Subject: BAR Actions - March 17, 2015 - 1309 W MAin Street

RE: Certificate of Appropriateness Application BAR 14-11-01 1309 West Main Street Tax Parcel 100016000 RAAJ Charlottesville, Owner/ Darrell Slomiany, Applicant

CITY OF CHARLOTTESVILLE BOARD OF ARCHITECTURAL REVIEW STAFF REPORT March 17, 2015

BAR 14-11-01 1309 West Main Street Tax Parcel 100016000 RAAJ Charlottesville, Owner/ Darrell Slomiany, Applicant Exterior Changes (revised)

RIGHT ELEVATION

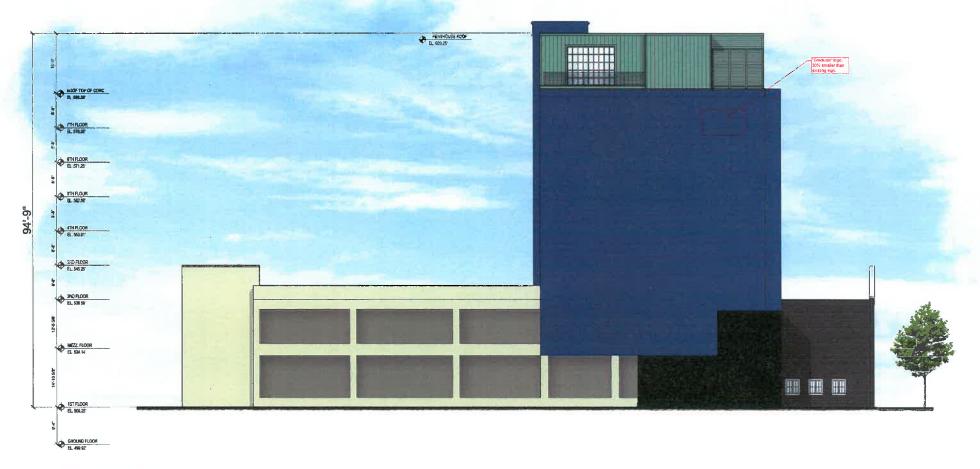
A final note, I have added the areas to the Left and Right Elevations where the existing Red Roof Inn signs are located. It is my understanding that we are permitted to locate new signage at these areas as long as they are 30% smaller. Please confirm this is acceptable.

LEFT ELEVATION

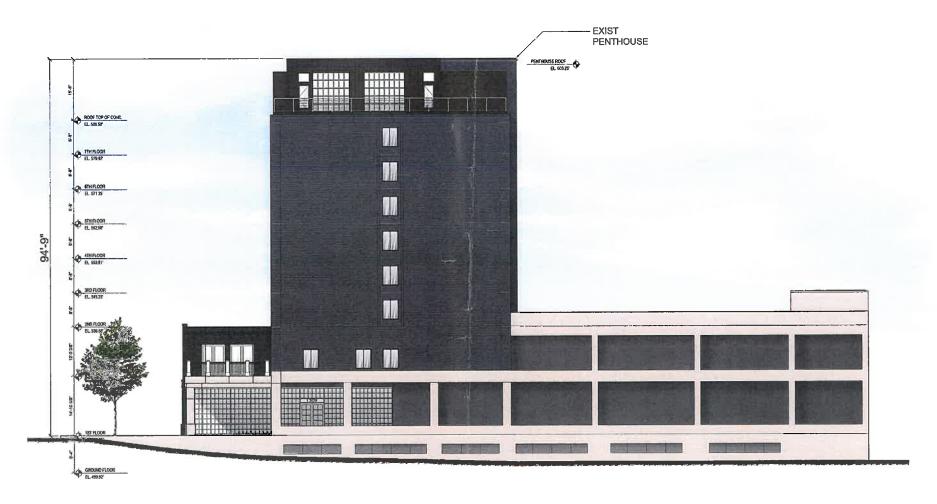
- Mechanical screen to be pulled back from West Main Street [to align with penthouse wall].
 Response The screen has been relocated to align with the addition, please see "Left Elevation".
- 2. Provide windows on the [penthouse] West Main Street façade. Response we have added windows that align with existing windows below, please see "Front Elevation".
- 3. Provide internal spacer bars on the ground floor [SDL] windows. Response windows air gap will receive internal mullion to achieve the appearance of a true divided light.
- 4. The lower rail shall match the penthouse rail. Response The railing will match, please see "Front Elevation" and "Right Elevation".
